Minimum Operational Performance Standards for Air Traffic Control Radar Beacon System/Mode Select (ATCRBS/Mode S) Airborne Equipment

Change 1

ED-73C, Change 1

Prepared by: WG-49

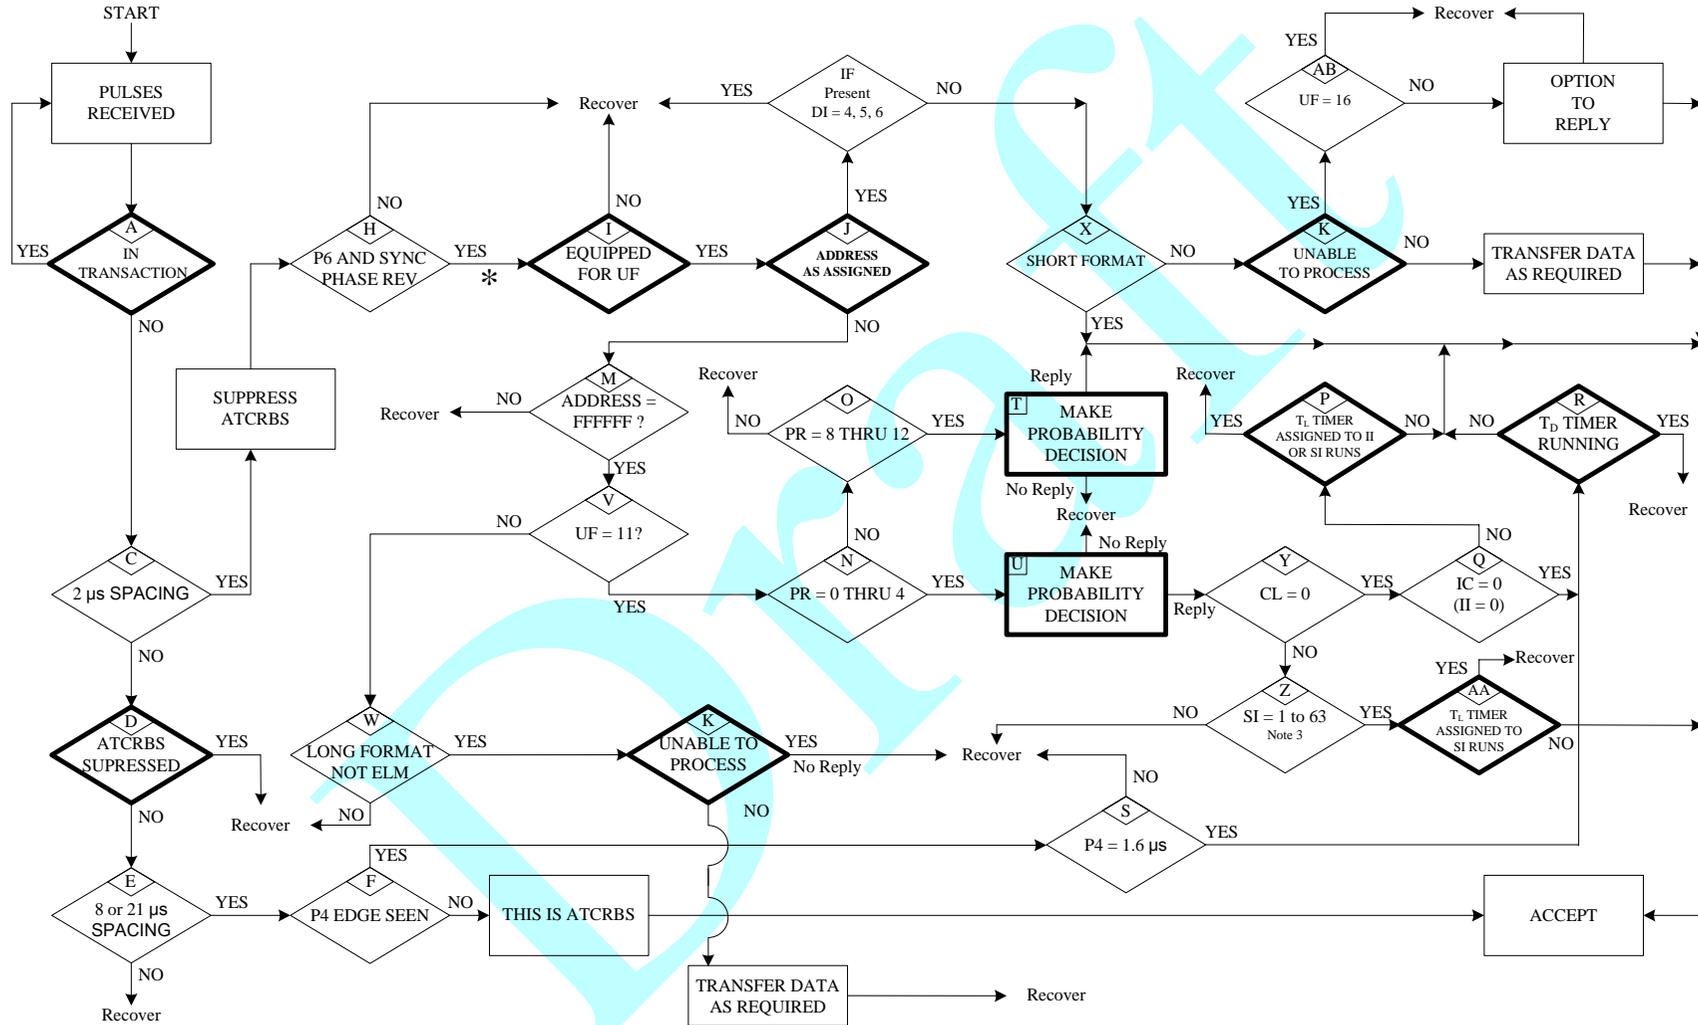
- (1.26) In EUROCAE ED-73C, in section §3.30.8.3, in order to correct references to the “maximum update interval” as detailed in Appendix B, Table B-2-1, and to also correct the specific maximum update interval for Register 60₁₆, which is specified in Table B-2-1 as 1.3 seconds, make the changes identified below in **yellow** to replace the word

“minimum” with the word “maximum,” and replace the actual values for the Register 60₁₆ maximum update interval:

- a. The **maximum** update interval at which Register 60₁₆ **shall** be reloaded with valid data is **1.3** seconds.
Note: *Register 60₁₆ is updated at least once every **1.3** second.*

- b. The time between availability of data that causes a change in Register 60₁₆ and the time that the change is made to Register 60₁₆ **shall** be less than the **maximum** update interval specified as **1.3** seconds.

- c. If Magnetic Heading data in Register 60₁₆ “MB” field bits 2 through 12 cannot be updated with valid data within **2.6** seconds (e.g., twice the specified **maximum** update interval of **1.3** seconds) then Status Bit 1 shall be set to ZERO (0) and bits 2 through 12 **shall** be set to ZERO (0).
